**ADDENDUM # 1  
To  
PROPOSAL # 25-22**

**Harrison School Demolition**

Date Issued: October 20, 2022  
Subject: Addendum No 1 to Request for Proposal  
RFP Name: Building Abatement, Demolition, and Restoration  
Former Harrison School, 2702 West Krause Avenue, Peoria, Illinois

**Re:** Former Harrison and McKinley Schools  
Visual Building Material Observations

1901 BUILDING  
GROUND FLOOR

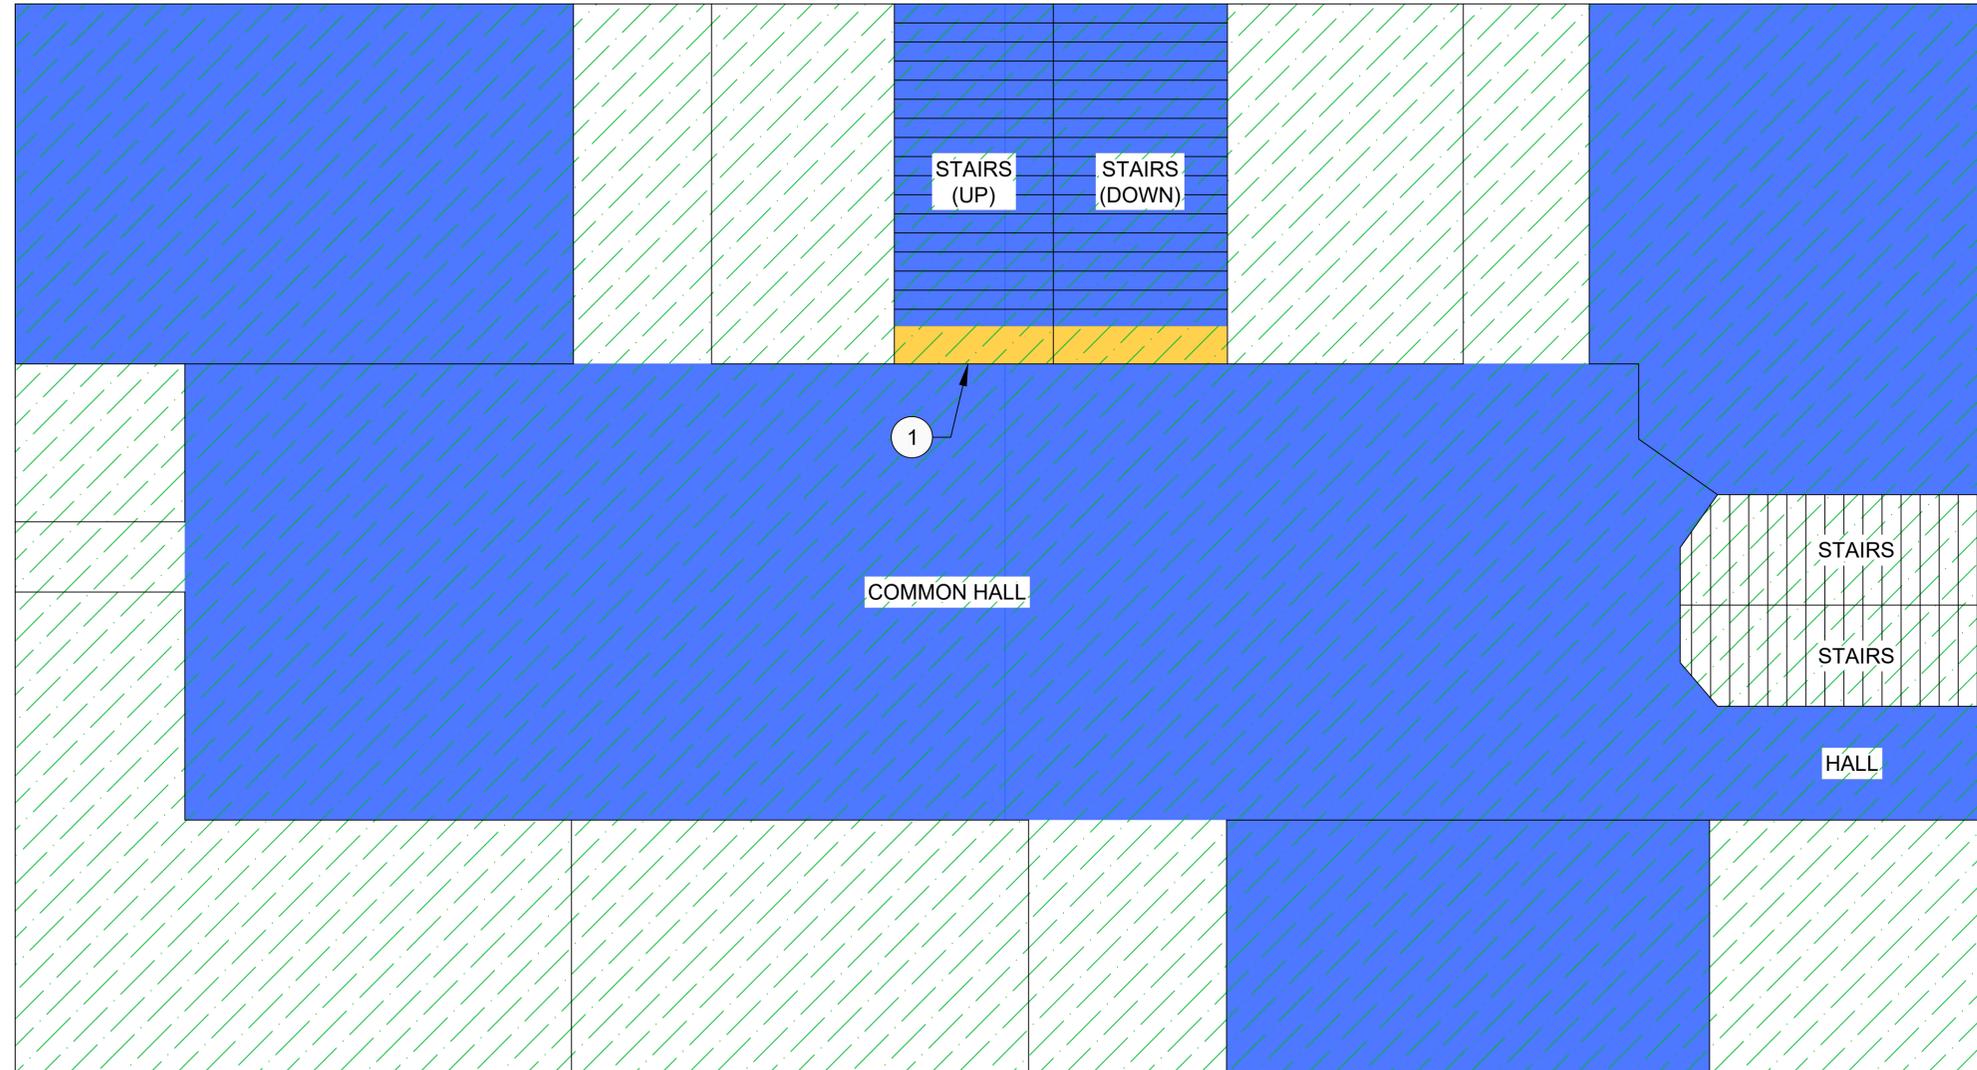
- ① STAIRWAY DOOR ASSUMED TO BE CONTAINING PCP-PAINT.

1901 BUILDING  
THIRD FLOOR

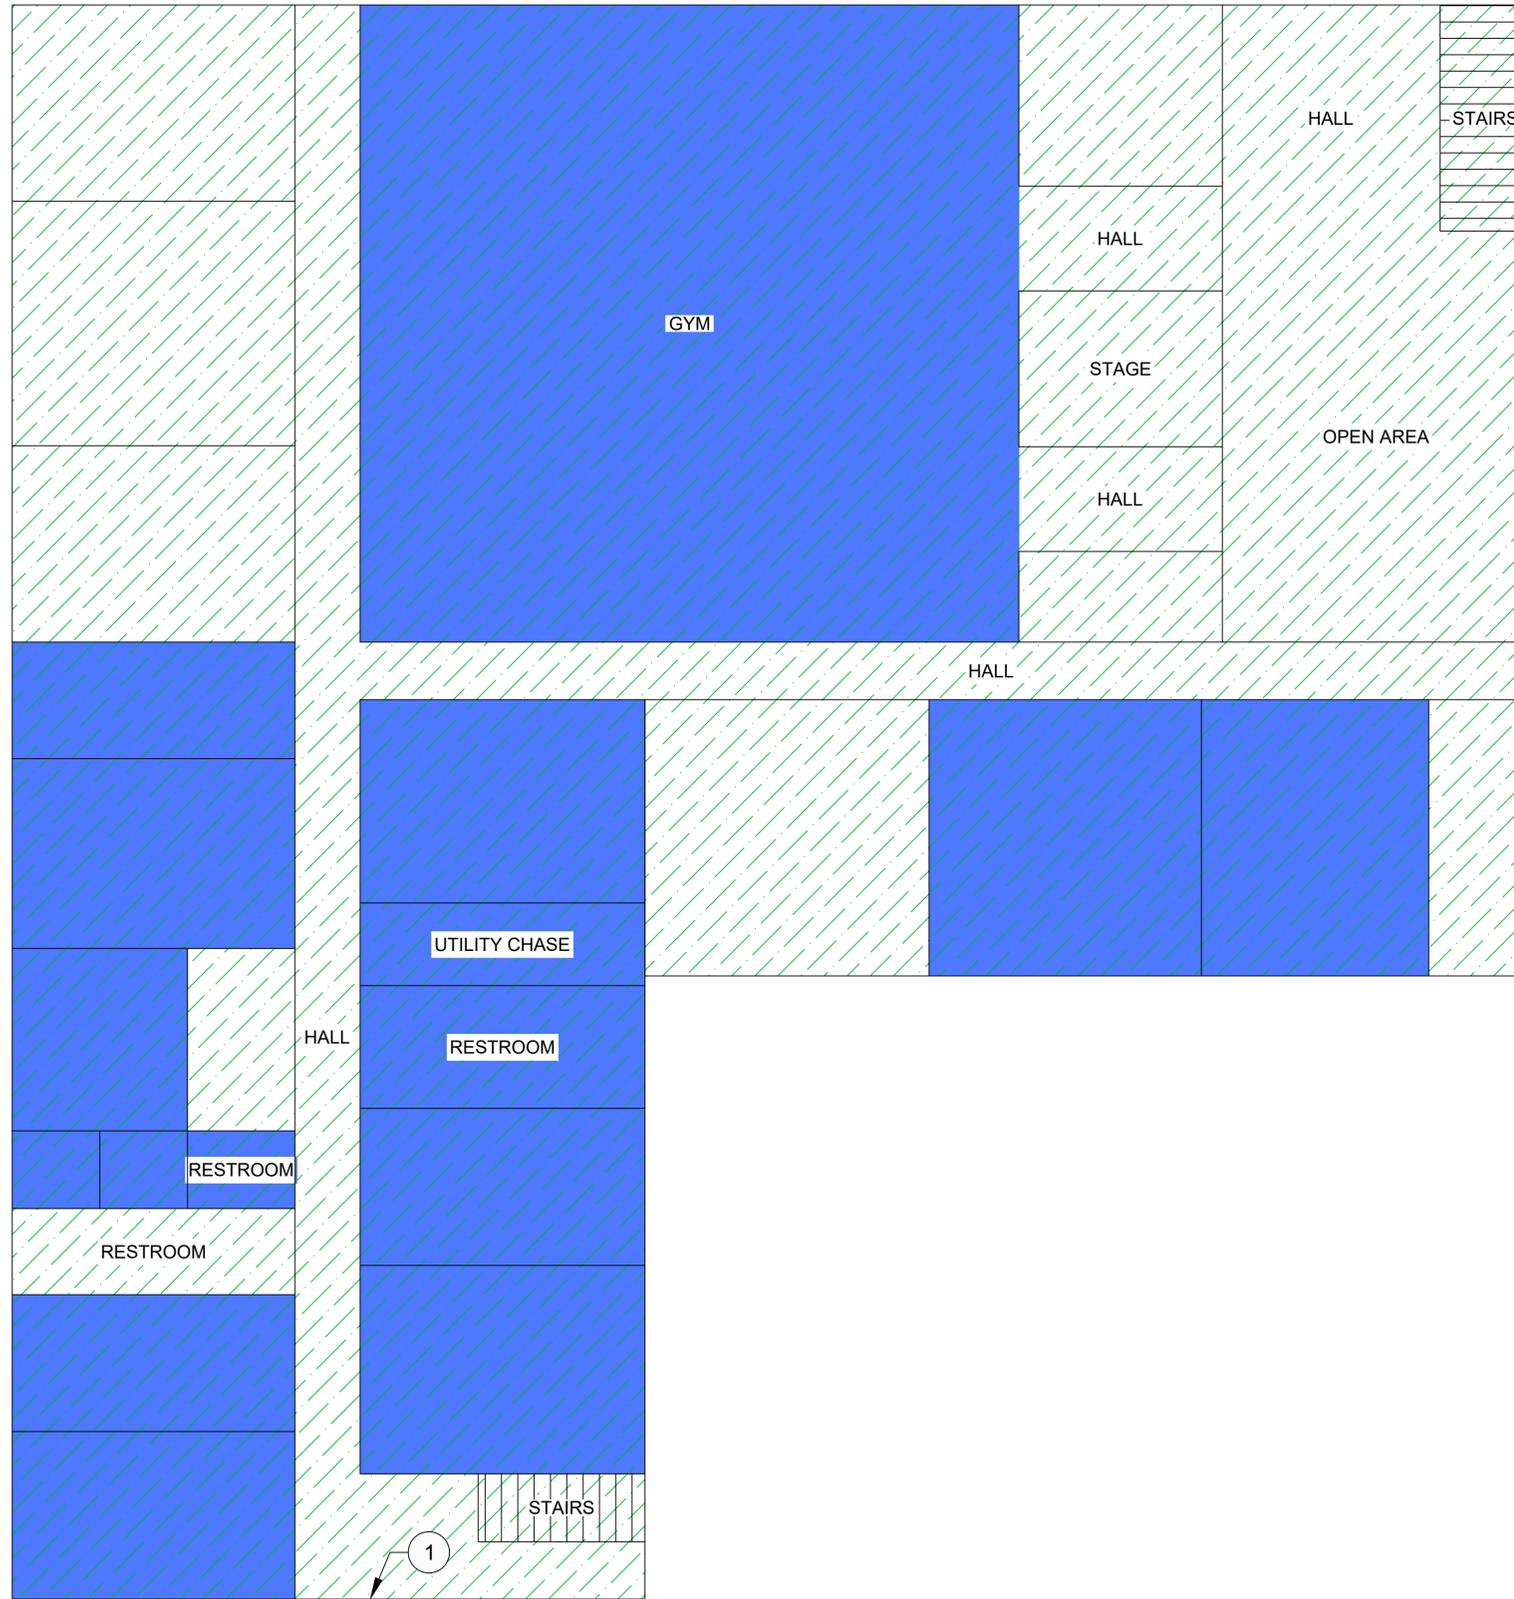
- ① COMPLETE FLOOR PLAN NOT AVAILABLE FOR THIRD FLOOR; NO ASBESTOS DATA AVAILABLE FOR THIRD FLOOR.

1921/1953 BUILDINGS  
GROUND FLOOR

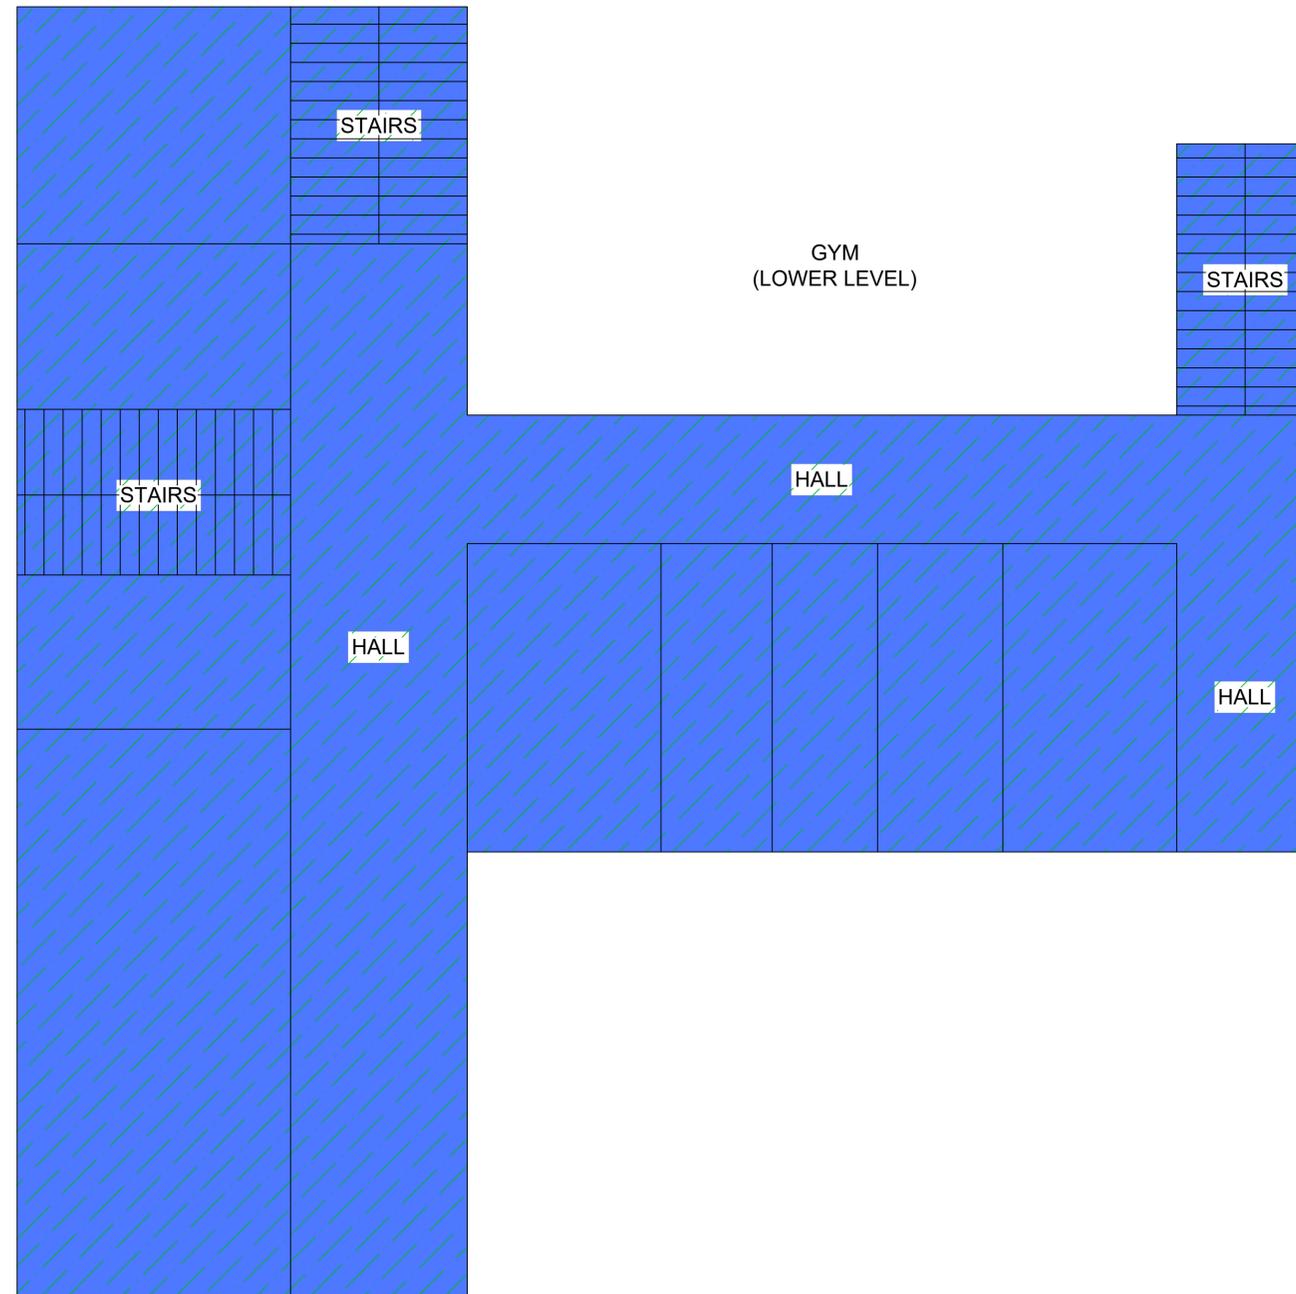
- ① SAMPLE COLLECTED ON EXTERIOR DOOR CONTAINS PCBs AT A CONCENTRATION GREATER THAN 50 PPM.
